TRAFFIC ENGINEERING ASSESSMENT
AND WASTE SERVICES REPORT

RESPONSE TO INFORMATION REQUEST

PROPOSED RESIDENTIAL DEVELOPMENT

10 – 18 KELSO STREET,
CHERMSIDE

Figure 1.1: Subject Site and Surroundings

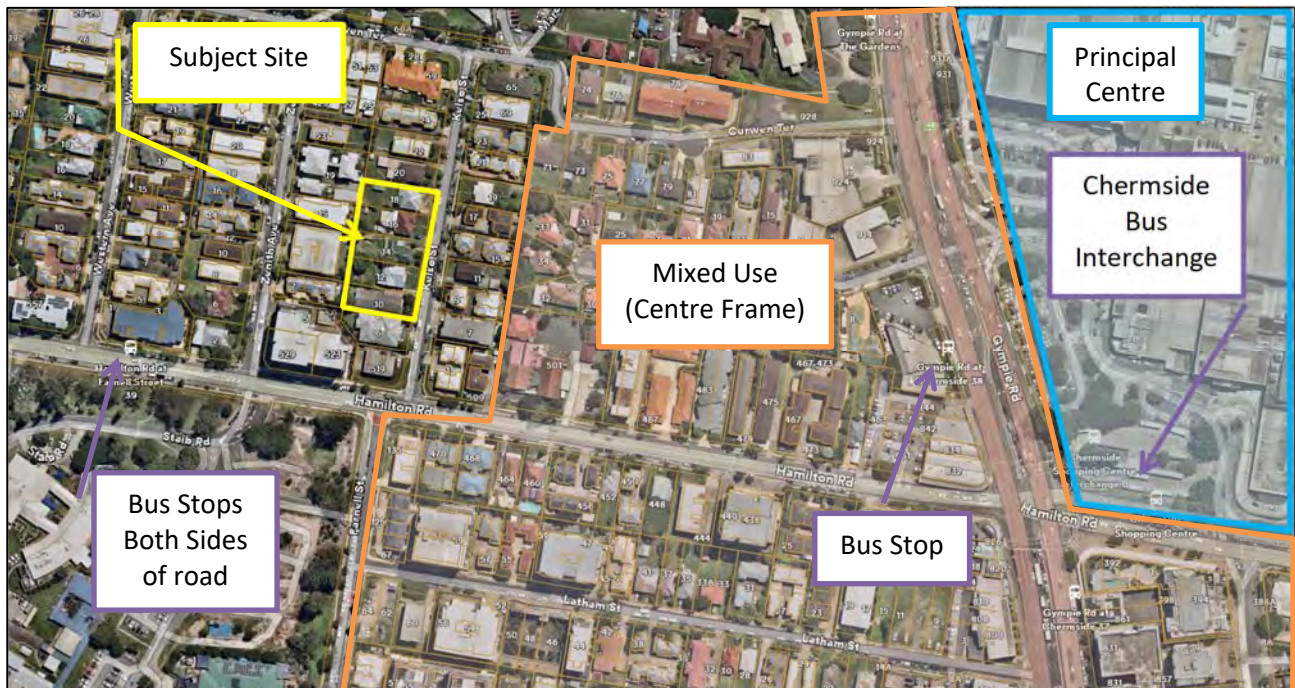
- b. *It is acknowledged that the submitted report references the draft More Homes Sooner proposal – as this application was lodged under version 35.00/2025 of City Plan 2014, the More Homes Sooner package was not an assessment consideration and therefore, further justification is required to endorse the proposed reduction in parking provision.*
 - i. *This could include elements such as site location and access to services, measures to support and encourage travel modes other than private car, local evidence relating to car ownership levels, etc.*
 - ii. *Provide revised reporting from an RPEQ to support the proposed 30% reduction in resident parking.*

The site is well serviced by public transport, with Figure 1.1 identifying the proximity of bus stops to the development. This includes:

- Bus stops on Hamilton Road within a 200m walk of the site. These stops service routes 325, 335, 340, 353 and 358, which combine to provide high frequency public transport options for the site.
- The bus interchange at the Chermside Shopping Centre, some 450m walk from the site.

Figure 7.1: Frontage Works Plan (Prepared by Coordinated Development Solutions)

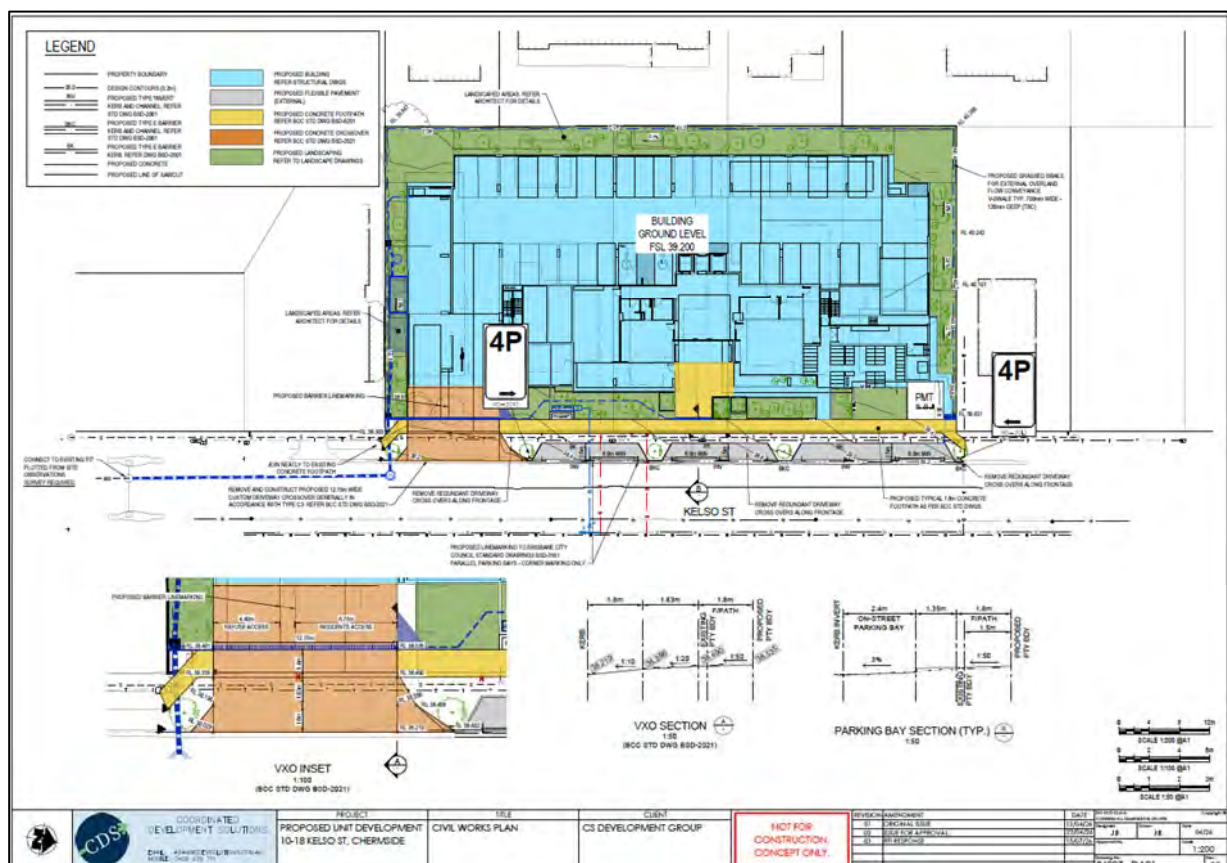
To consider the implementation of the proposed indented parking on Kelso Street at the frontage of the development, the following must be provided with schematic plans:

- The indented bays are to be marked with corner markings as per standard drawing BSD-3161.
- Provide an additional pair of the existing 4P signs at each end of each bank of parking spaces for clarity, and the small sections between bays will need to be yellow lined.
- A detailed schematic design for signs and lines related to the proposed indented parking on Kelso Street, revised by a Registered Professional Engineer of Queensland (RPEQ), must be submitted to Council for consideration.

The requested plan has been prepared by Coordinated Development Solutions, approved by Adam Heather (RPEQ #29676). Reproduced in Figure 7.1, the plan shows appropriate 4P signage and provision of seven (7) kerbside parking bays.
